The Proposed EPA Yucca Mountain Radiation Standard—Nevada's views

Victor Gilinsky
Nevada consultant
NWTRB Fall Meeting, Las Vegas,
November 8, 2005

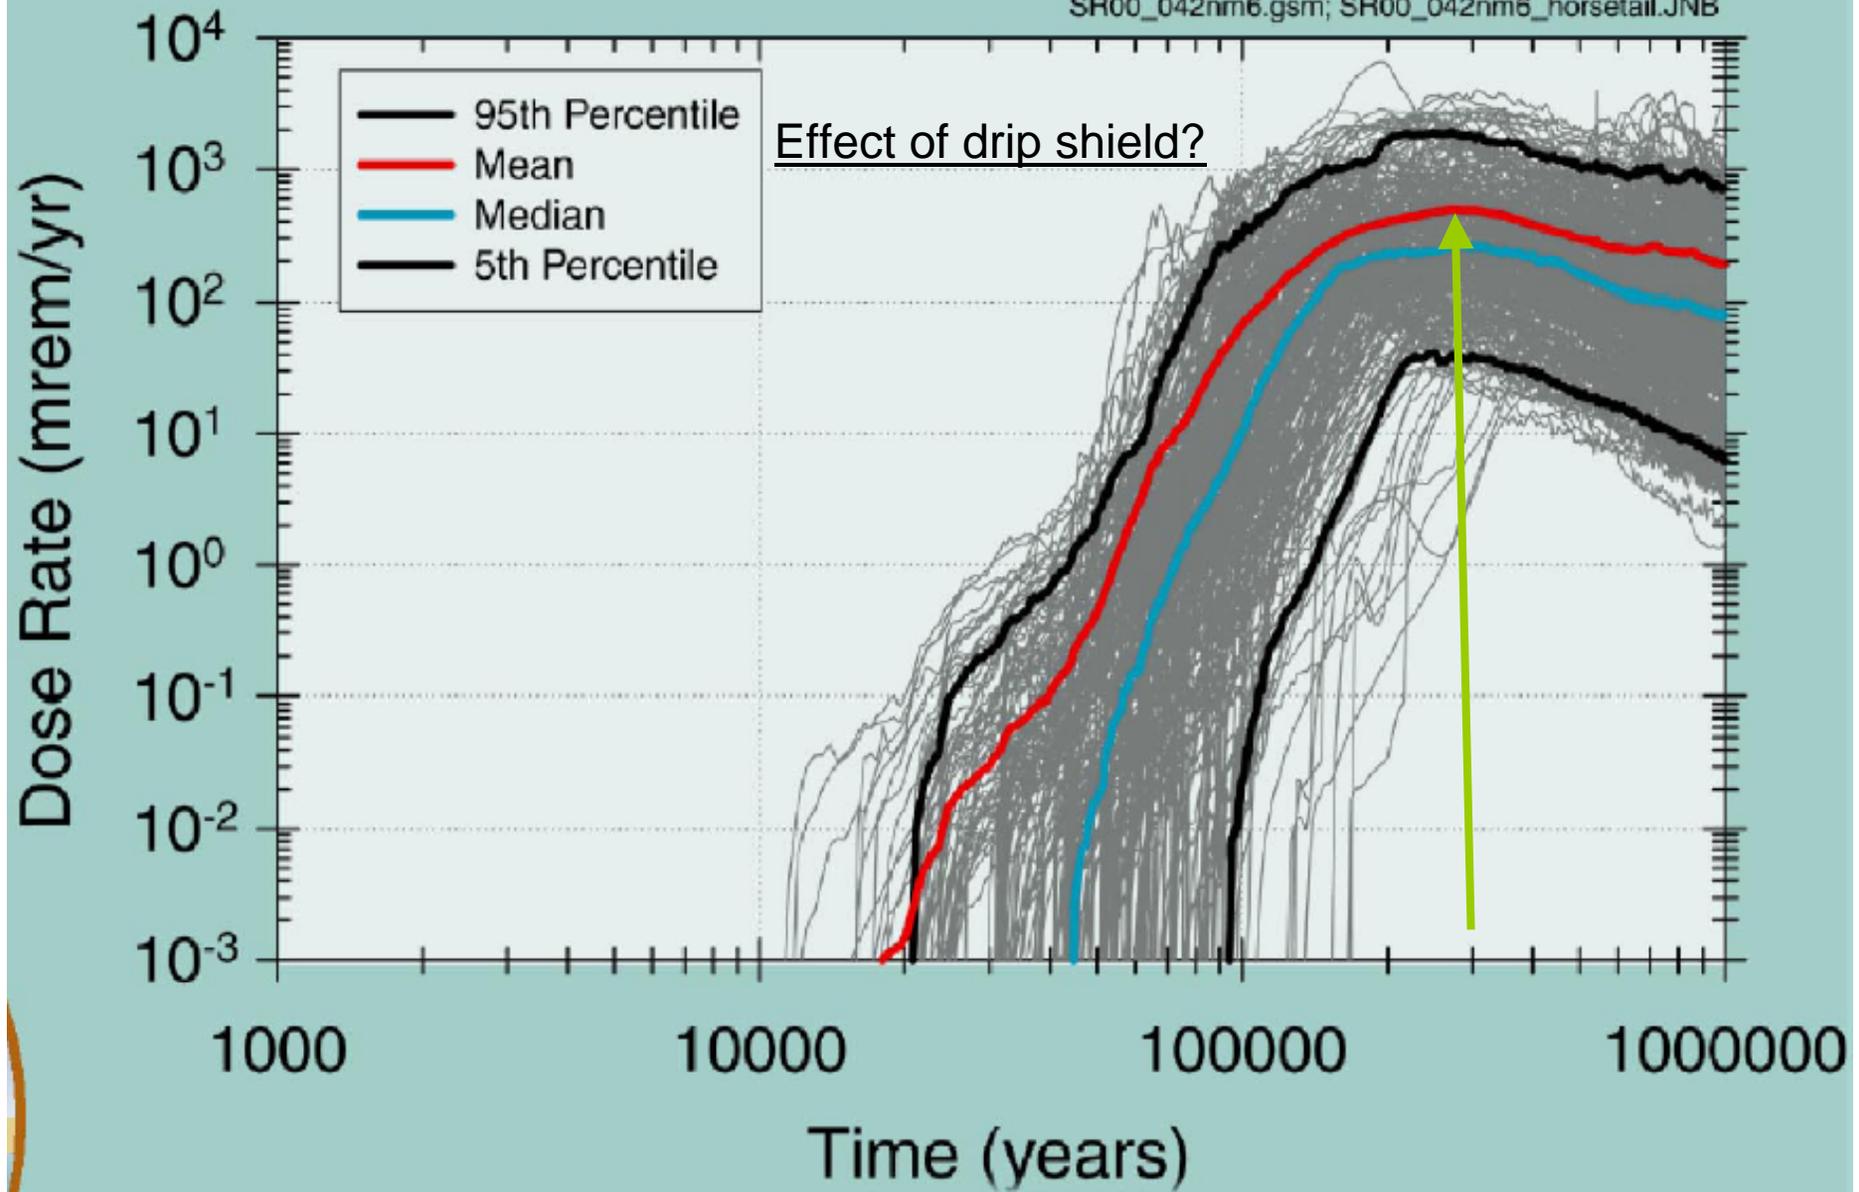
- "350 mrem/year" is approximately 1,000 mrem/year in terms of the *mean* TSPA results (see next slide—difference between blue and red line)

Why worry if peak is in remote future?

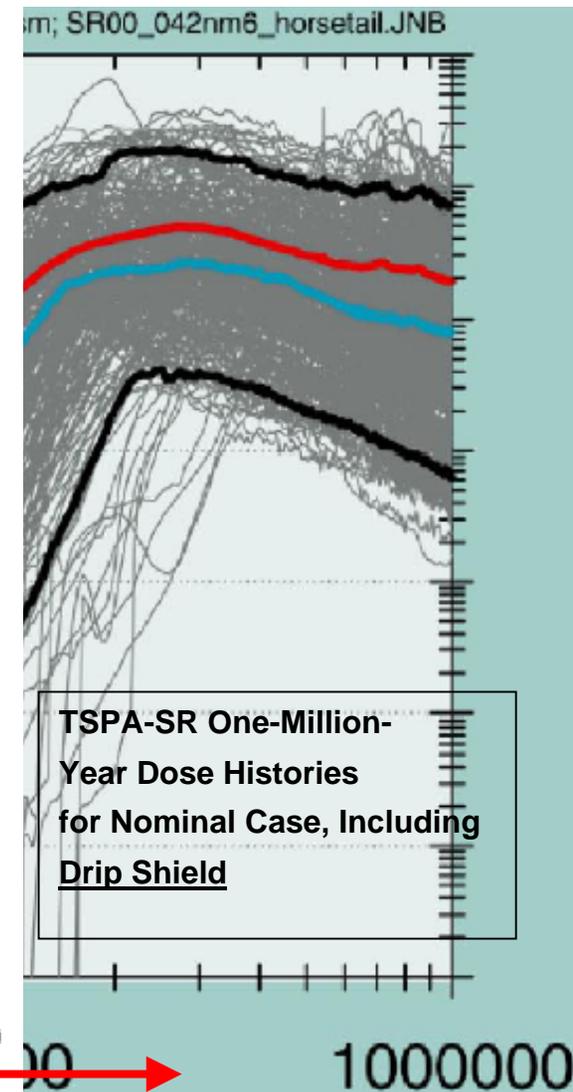
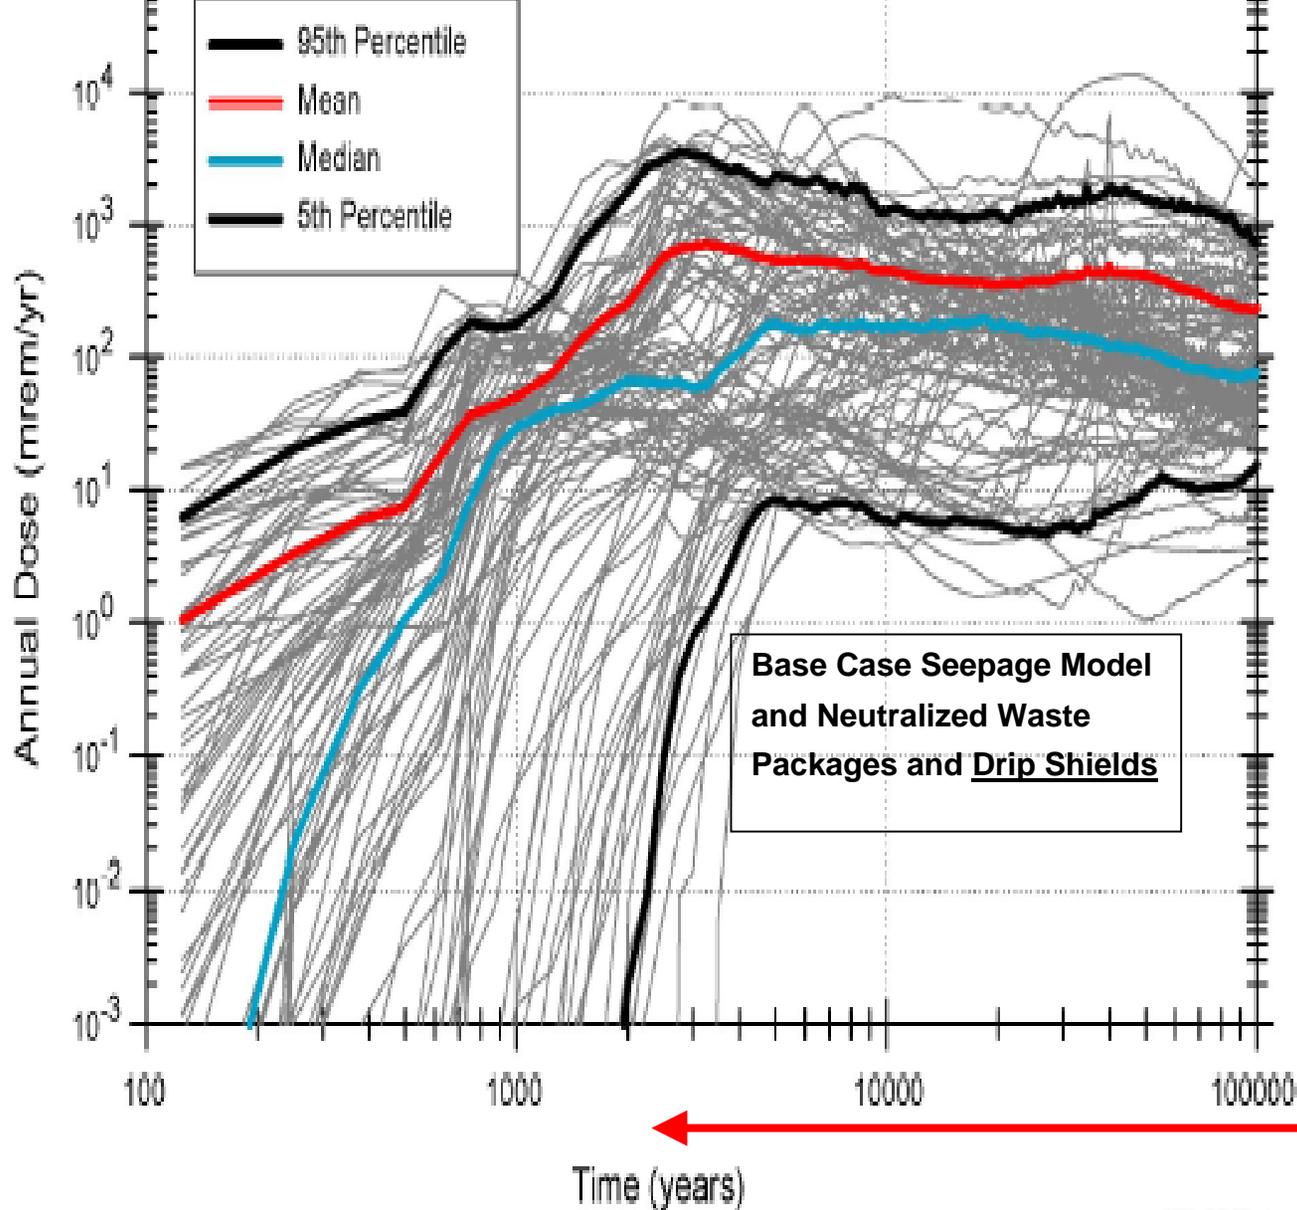
- *Because it isn't necessarily in the remote future*—it could come much earlier (see next slide).
- The supposed long times for the Yucca Mountain peak—hundreds of thousands of years—are a construct of DOE's TSPA computer simulation model
- In particular, they are the result of highly optimistic assumptions about the *key uncertainty—waste package corrosion*
- DOE's "time" is just the time parameter in the *TSPA simulation model*. No one knows when peak doses would *really* occur.
- At this point, DOE's simulation result should have no claim on our confidence—it is the scientific brief of an interested litigant, a brief not yet seriously tested
- It is improper for EPA (and NRC) to assume the peak is far off and then write permissive safety rules based on that assumption
